UNITED STATES
DEPARTMENT OF THE INTERIOR
BUREAU OF LAND MANAGEMENTFORM APPROVED
OMB NO. 1004-0137
Expires: January 31, 2018**SUNDRY NOTICES AND REPORTS ON WELLS**
*Do not use this form for proposals to drill or to re-enter an abandoned well. Use form 3160-3 (APD) for such proposals.*5. Lease Serial No.
NMNM100549

☐ Oil Well ☒ Gas Well ☐ Other8. Well Name and No.
HH SO 17 20 FED 002 5H

Changes to APD/COA for Federal Well

Summary of Changes to original APD

Drilling Sequence & Slot Designation

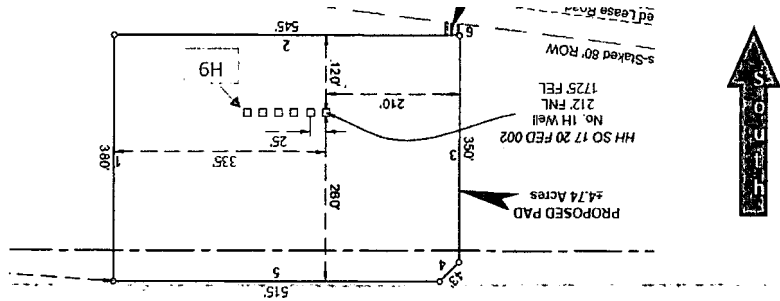
- A variance from the Onshore Order 2 where it states "(A full BOP Test) shall be performed: when initially installed and whenever any seal subject to test pressure is broken." We propose to break test if able to finish the next hole section within 21 days of the previous full BOP test. Upon the first nipple up of the pad a full BOP test will be performed. A break test will consist of a 250 psi low / $\geq$ 5,000 psi high 10 min ea test against the connection that was broken when skidding the rig. A break test will not be performed on our last production section. A break test will only be performed on operations where BLM documentation states a 5M or less BOP can be utilized.

See drilling sequence below that indicates the potential hole sections break testing can be performed given they meet the above criteria.
